# Thoughts on Comment 128 (linear fit to ICR curve)

Charles Moore, SPG of Agilent Technologies

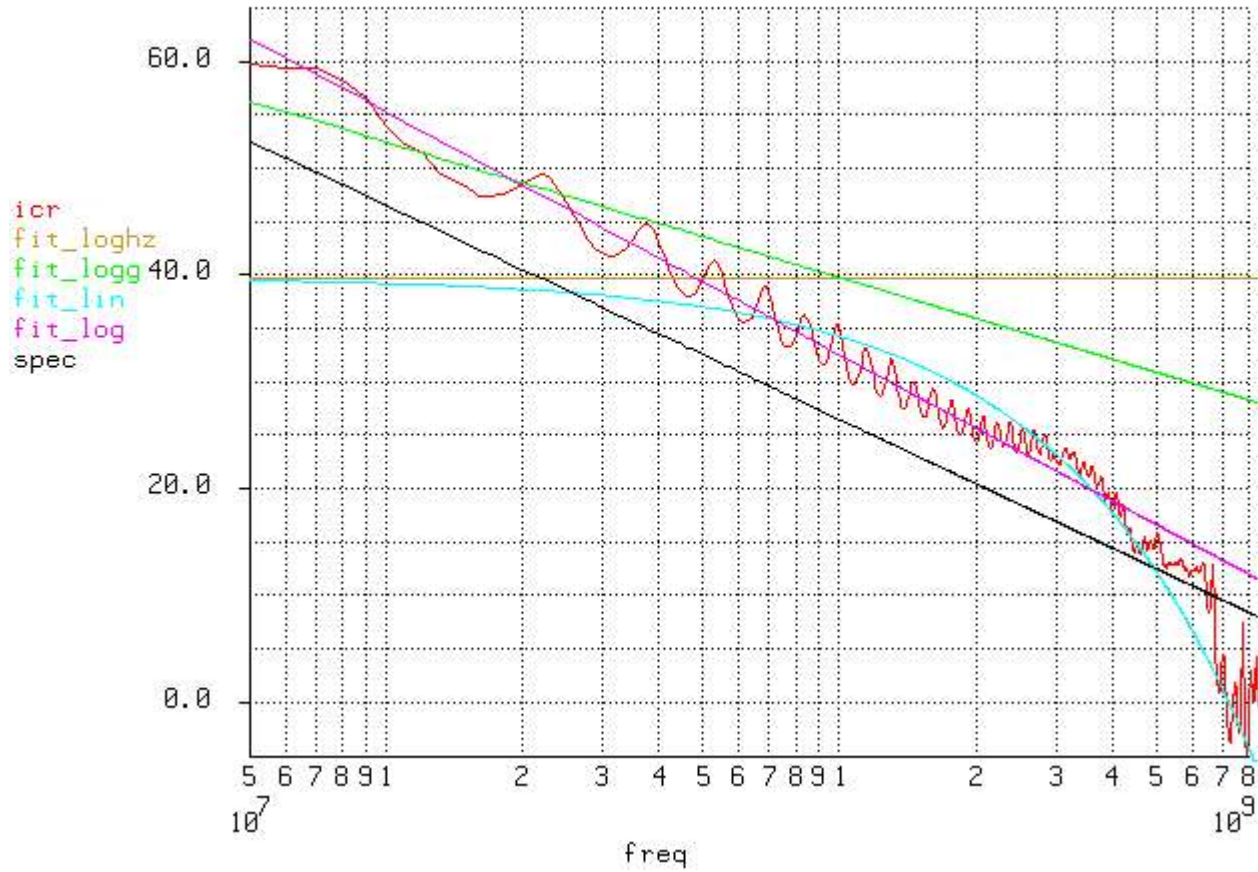
I tried 4 ways of fitting the ICR curve:  
In linear frequency:

Or in log frequency:

On these plots:

The Red curve is ICR

The Brownish curve is a literal following of the D' Ambrosia equations.

The Green Curve is the D' Ambrosia equations assuming frequency is in GHz rather than Hz

The Light Blue curve is a linear frequency fit

The Magenta curve is a log fit using equations given below

The Black curve is the ICR spec.

All fits were done over the frequency range 100MHz-5GHz

I think that the magenta curve is the best fit and recommend that we use it.

# I recommend that we propose acceptance of comment 128 in principal with recommended verbiage:

The ICRLOG is defined to be the least mean square fit of the ICR with frequency plotted on a log scale, and is defined by Equations (69-20) through (69-24). The sums in these equations are to be performed over the range of values such that  $f_n$  is in the range of frequencies for which IRC is specified.
